# Access Compliance Report Public Rights-of-Way (Curb Ramps)

Main Street: LANGFORD\_RD Cross Street: RANUNCULUS\_ST Location: E

ADA ID: RPRK211111115326 Ramp Type: Type 4 - Parallel Initial Pass/Fail: Fail Overall Compliance: No Severity Score: 32

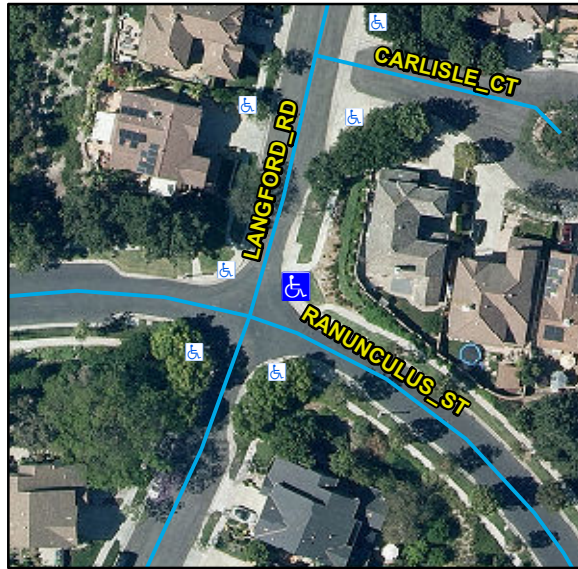
| Compliance | Description                   | Data       | Compliance | Description                   | Data |
|------------|-------------------------------|------------|------------|-------------------------------|------|
| Yes        | Ramp Run Slope LT (%)         | 1.3        | No         | Ramp Run Slope RT (%)         | 15.5 |
| No         | Ramp Cross Slope LT (%)       | 2.4        | Yes        | Ramp Cross Slope RT (%)       | 2    |
| N/A        | Gutter Cross Slope (%)        | N/A        | No         | Perpendicular Joint Present   | No   |

Remove & Replace Curb Ramp With Two New Directional Ramps or Equivalent.
